DCS Technical Team Repair/Installation Request

COMMUNIC
1.	Location(s)		Control #
	South LA Sheriff Station, T 1310 W. Imperial Highway	Cechnology IT Room , Los Angeles, California 90044	SLA-01
2.	Statement of the Problem(s)

Two FT8900s for 6m and 10m Recommended Configuration

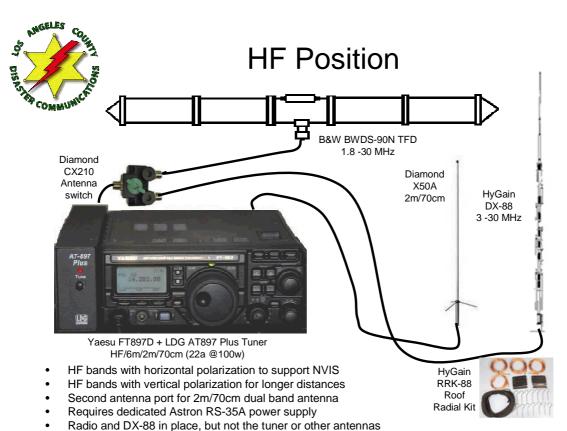
A. Two FT8900 quad band radios are installed each with single band antennas attached; one for 6m and one for 10m. The radios function on all bands but high SWR on the other 3 makes them unusable there. Without 440 capability, SLA can not communicate with its contact city radio organizations. [Note Gardena DCS operates on the Part 90 commercial UHF band]. B. The FT897 HF radio attached to the DX-88 trap vertical antenna can't support NVIS. It also is not equipped with an antenna tuner.

Radios are in place attached to single band antennas.

3.	Recommended Solution(s) A. For each FT8900 radio, replace the single band antenna with two dual band antennas; namely a Diamond CP 610 for 6m and 10m and a Diamond X50A for 2m and 440. Add a Comet CF-530C duplexer to connect the antennas to the radio. This will also provide 440 capabilities to communicate with the contract cities. See attached diagram. [Consider Part 90 UHF radio and antenna to communicate with Gardena DCS]. B. To provide NVIS with the FT897, add a B&W BWDS-90N terminated folded dipole and a LGD AT-897 tuner. Add a Diamond CX-210 antenna switch to connect the trap vertical and the folded dipole to the tuner. Consider adding the roof radial kit to the DX-88 to improve performance. Add a Diamond X50A to complete the radio capability. See attached diagram.
